12024  
Its project number  
4.15.2014  
date  
bgp  
drawn by  
bgp  
checked by

3-30-15  
sheet title  
**FOUNDATION PLAN**  
sheet number

**FP-2**  
**AS BUILT**  
03/07/2016

1 SOUTH RUSK WALL PLAN  
SCALE: 1/8" = 1'-0"

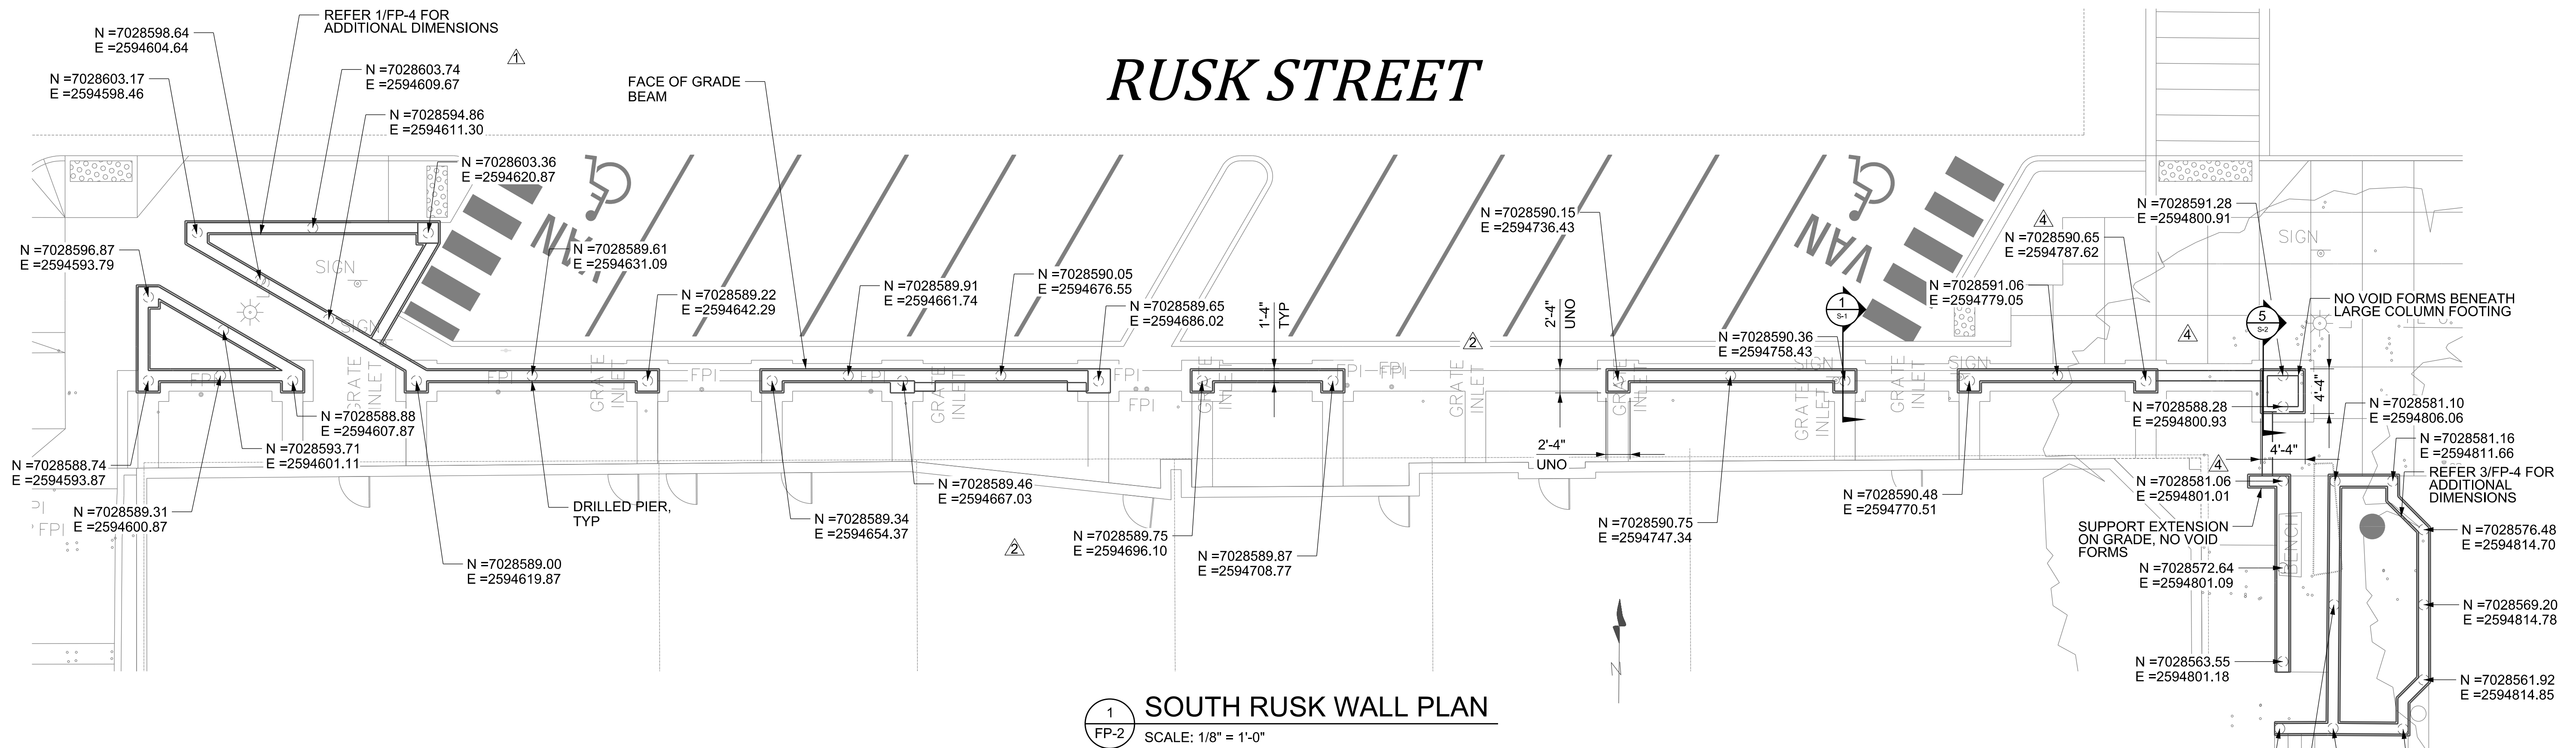
- REMOVED SECTIONS OF WALL, ADDED STEPS, ADJUSTED PIER LOCATIONS. 12-30-14
- MODIFIED WALL AND PIER LOCATIONS. 4-15-14
- ADJUSTED WALLS AND PIER LOCATIONS 7-03-14
- REMOVED NOTE 7-22-14
